JOB NO. MA24-04

LAHAINA SMALL BOAT HARBOR WATER SYSTEM LEAK ASSESSMENT AND REPAIR LAHAINA, MAUI, HAWAII

NOTE: THESE AS-BUILT PLANS HAVE BEEN MARKED UP TO SHOW THE SCOPE OF WORK FOR WATER SYTEM LEAK ASSESSMENT, PRESSURE TESTING, REPAIR AND NEW WATER SYSTEM WORK.

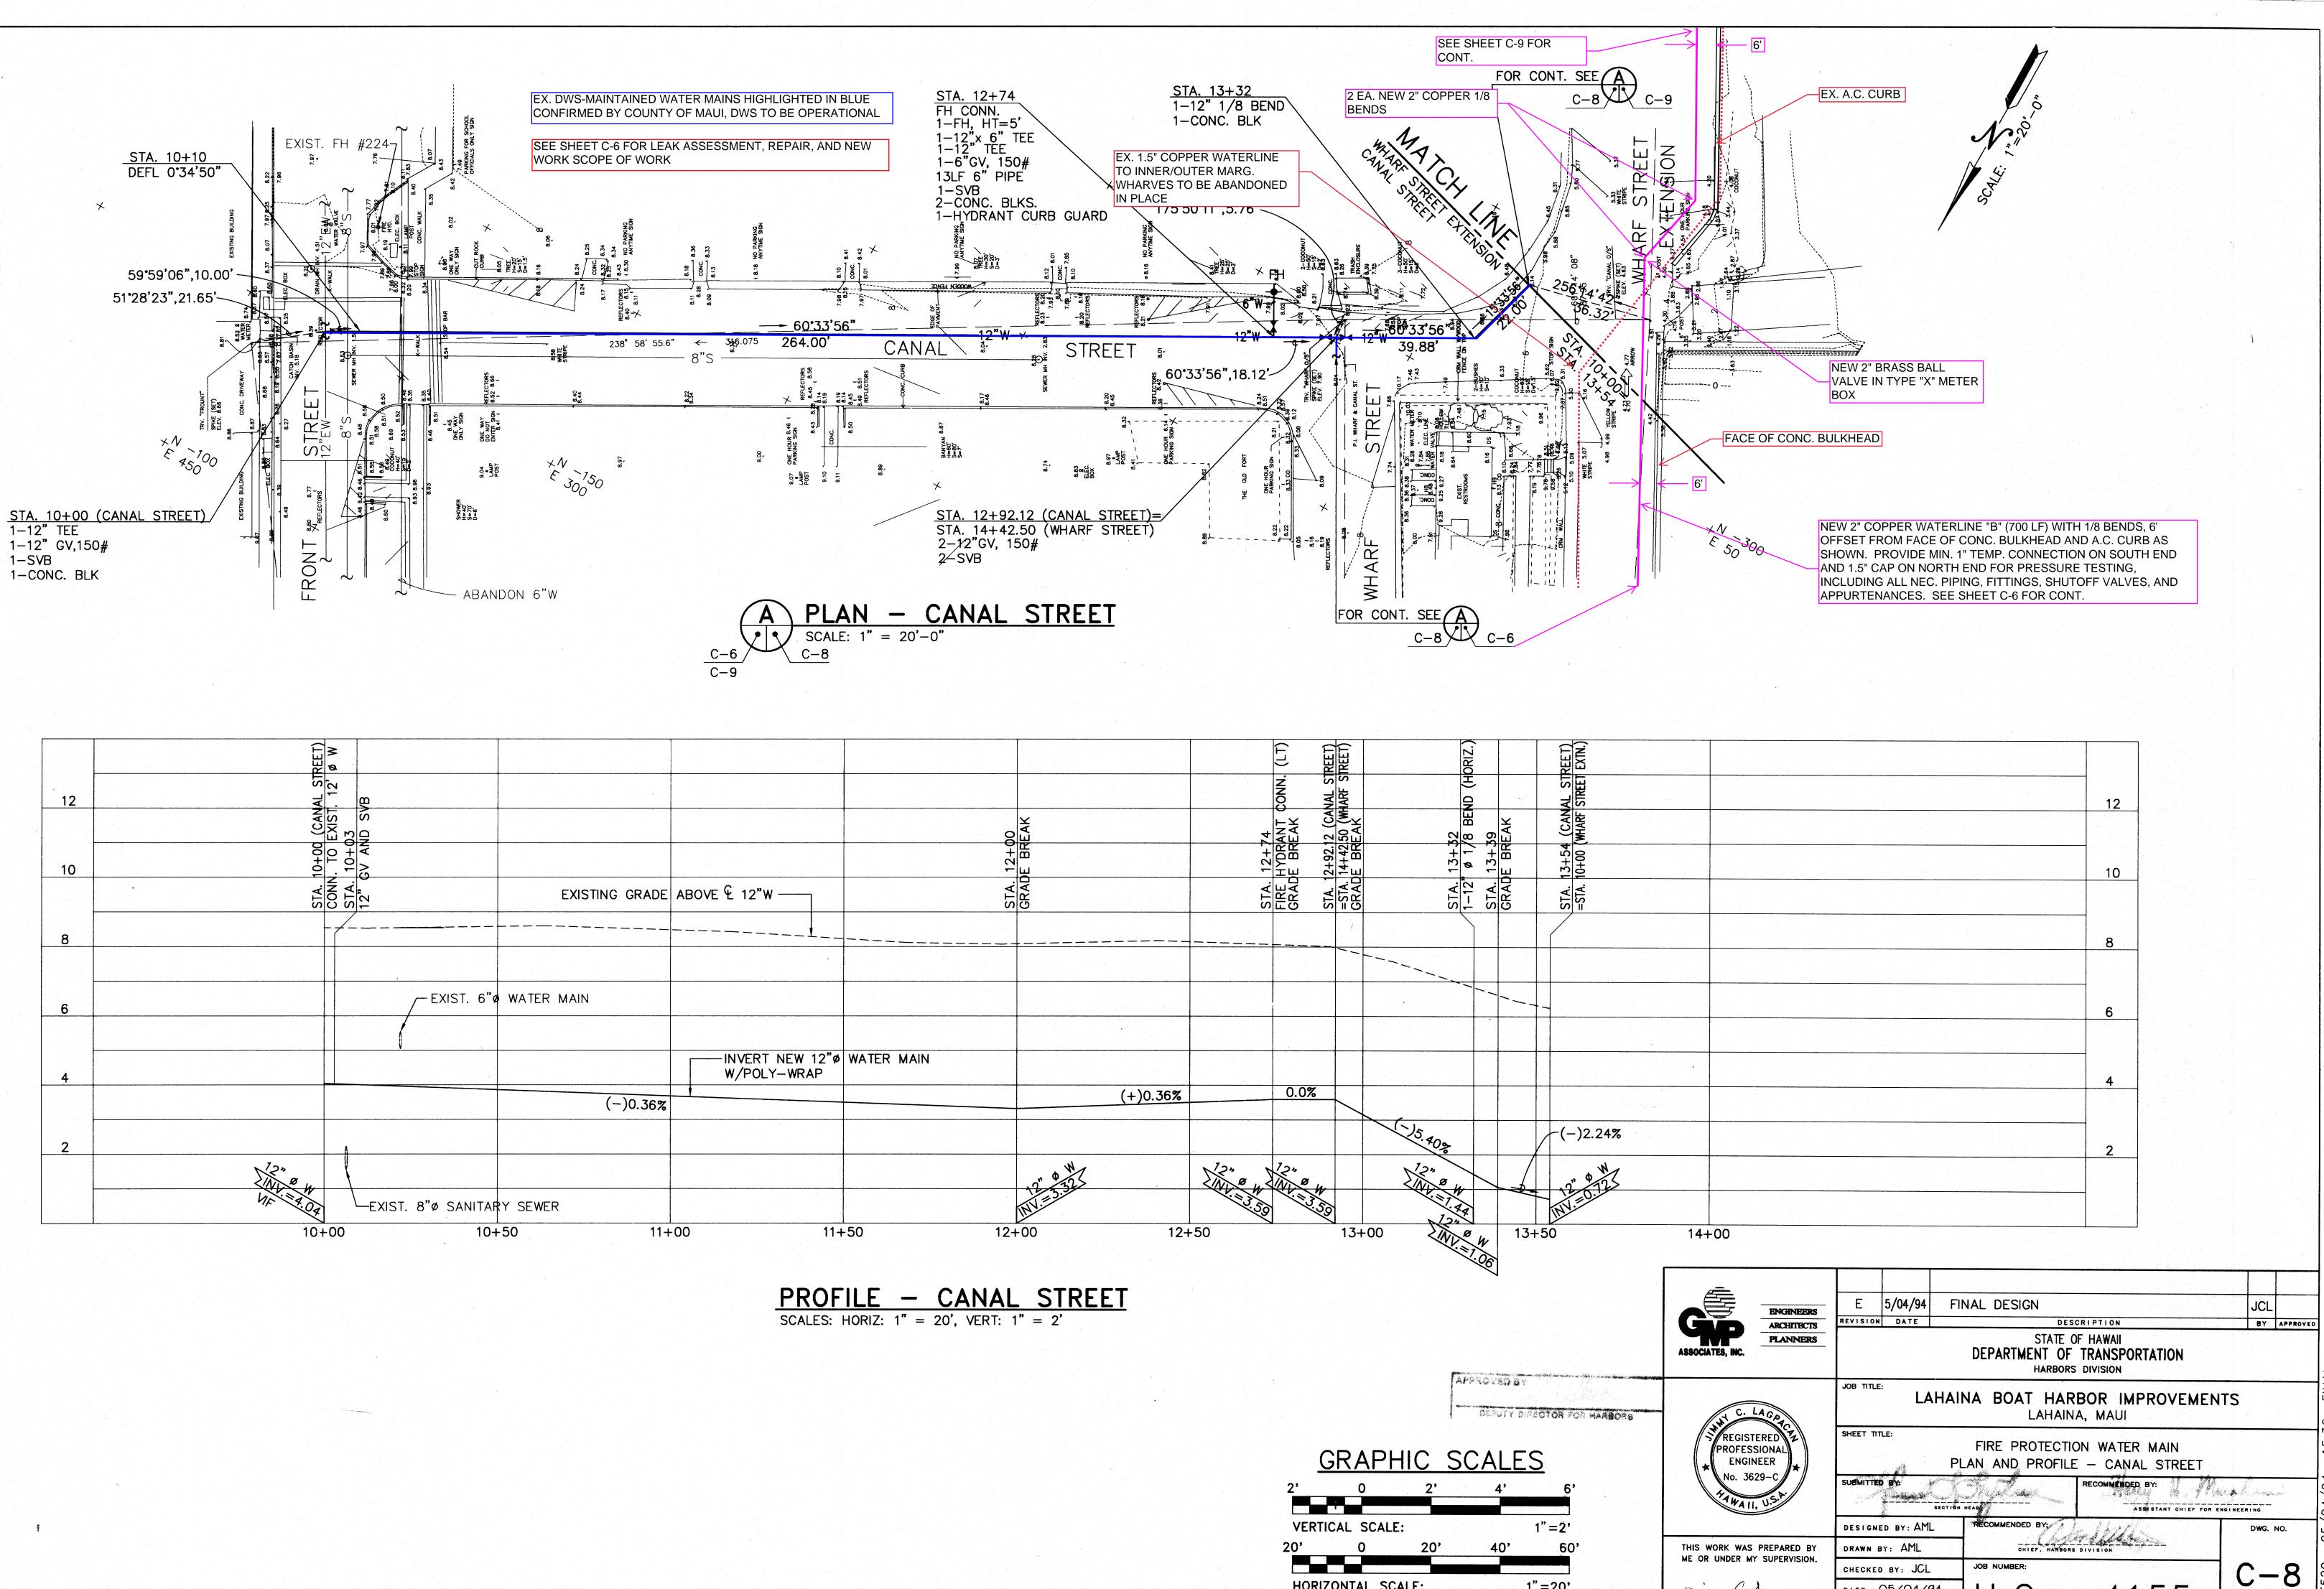
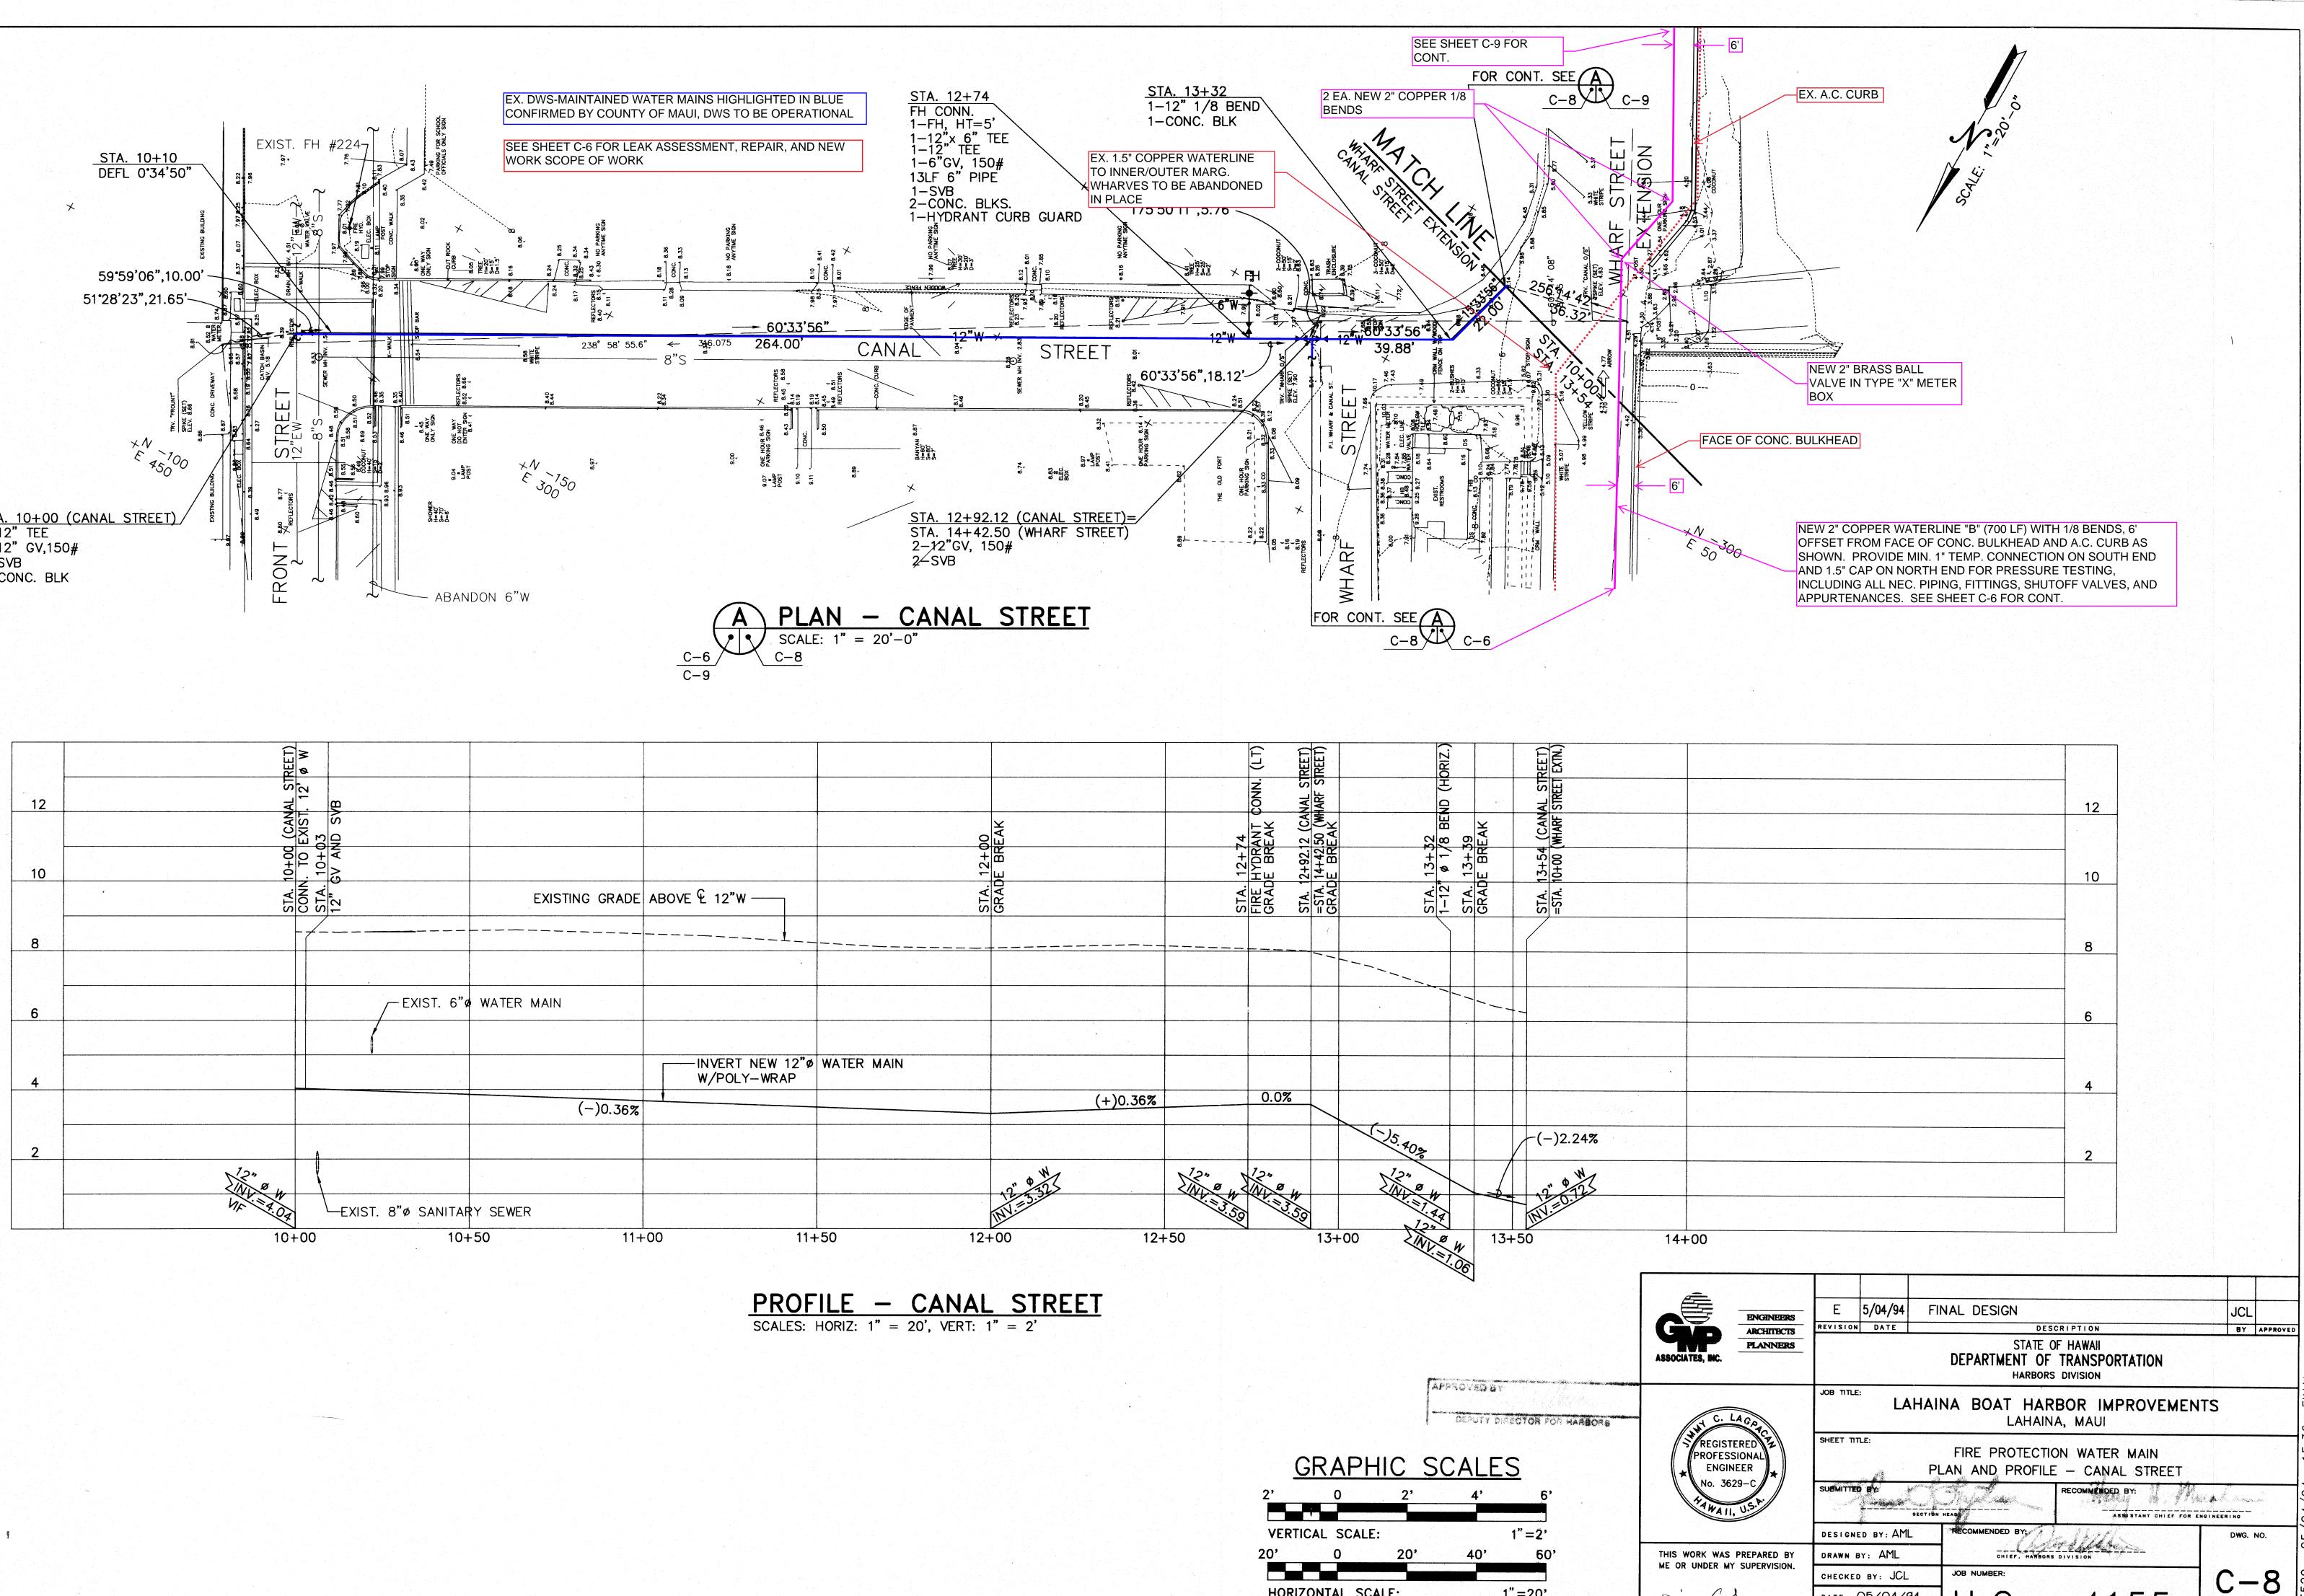
### NOTE: THIS SHEET FOR INFORMATION PURPOSES ONLY. NO LEAK
